APPLICATION NO.	FILING DATE	FIRST NAMED INVENTOR	ATTORNEY DOCKET NO.	CONFIRMATION NO.	
10/622,960	07/18/2003	Ralph D. Geater	GEAT100USA 4002		
24339	7590 11/29/2004		EXAMINER		
	LINNER, JR.	SZUMNY, JONATHON A			
212 COMME	ND ASSOCIATES ERCIAL ST.	ART UNIT	PAPER NUMBER		
HUDSON, WI 54016			3632		
			DATE MAILED: 11/29/2004

This is the second office action for application number 10/622,960, Fastener Technology, filed on July 18, 2003.

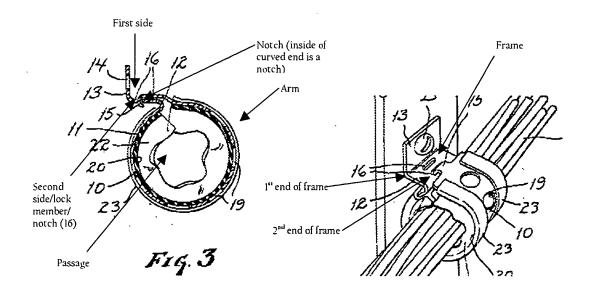
Claims 1, 2, 6-8, 11-15, 19 and 20 are rejected under 35 U.S.C. 102(b) as being anticipated by U.S. Patent number 2,340,713 to Tinnerman.

Tinnerman '713 discloses a unitary device (above) comprising a rectilinear frame (above). a planar leg (13) communicatively connected to the frame at the first end and on a first side of the frame, and a first end of a curvilinear arm (above) connected to the frame and defining a cylindrical passage (above) with open ends, wherein the frame has first and second ends (above) and a predetermined length, wherein the leg has a predetermined configuration with a predetermined area and depends from the first end of the frame at a right angle thereto, wherein the device includes connecting means/screw (B), wherein an aperture (14) is disposed at a predetermined location in the leg at a central area thereof, wherein the device could inherently attach to a wall stud, wherein the arm pivotally depends from the second end and second side of the frame, wherein the arm is flexible (column 1, line 49, "spring"), wherein the device can be/is inherently separated a predetermined distance from an external base object., wherein a lock member (above) is connected to the frame on a second side (above) thereof, wherein the second end of the arm has a locking end which releasably mates with the lock member to open and close the passage, wherein the lock member and locking end have complementary mating notches (above), wherein the cylindrical passage is oriented parallel with the plane of the leg, wherein the passage could inherently be adapted to be disposed any number of various distances away from a stud, including approximately 1 5/8 inches.
